Access Compliance Report

Public Rights-of-Way

Intersection ID: 26464	Main Street: BEVINGTON_PL	Cross Street: ENCLAVE_PL	Location: SW
ADA ID: 5A70CDE8831C	Ramp Type: PerpDiag	Initial Pass/Fail: Fail	Overall Compliance: No
Severity Score: 13.75			
Codes/Mitigation Info/Possible Solution		Field Measurements/Component Compliance

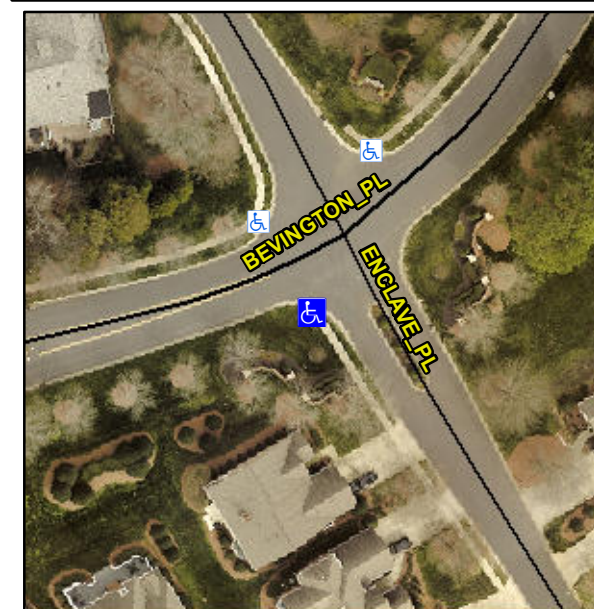
Not Found, R304.2.2, R304.5.3

Compliance	Description	Data	Compliance	Description	Data
N/A	Ramp Length (in)	48.0	No	Ramp Slope (%)	9.7
Yes	Ramp Width (in)	48.0	No	Ramp XSlope (%)	2.6
N/A	Flare Type LT	N/A	N/A	Flare Type RT	N/A
N/A	Flare Slope LT (%)	N/A	N/A	Flare Slope RT (%)	N/A
N/A	Flare Traversable LT?	N/A	N/A	Flare Traversable RT?	N/A
N/A	Landing Length (in)	N/A	N/A	DWS Provided?	N/A
N/A	Landing Width (in)	N/A	N/A	DWS Contrast?	N/A
N/A	Landing Slope (%)	N/A	N/A	DWS Length (in)	N/A
N/A	Landing X Slope (%)	N/A	N/A	DWS Full Width?	N/A
N/A	Landing Curb? (Y/N)	N/A	N/A	DWS Offset (in)	N/A
N/A	Shared Landing?	N/A			
N/A	Gutter Ponding?	N/A	N/A	Gutter Slope (%)	N/A
N/A	Gutter Lip Ht (in)	N/A	N/A	Gutter X Slope (%)	N/A
N/A	Painted X Walk1?	No	N/A	Painted X Walk2?	No
	X Walk 1 Direction	To NE		X Walk 2 Direction	To NW
N/A	X Walk 1 Width (in)	N/A	N/A	X Walk 2 Width (in)	N/A
	X Walk 1 Slope (%)	3.6		X Walk 2 Slope (%)	0.6
	X Walk 1 X Slope (%)	2.1		X Walk 2 X Slope (%)	2.6

Remove & Replace Curb Ramp With Two New Directional Ramps or Equivalent.
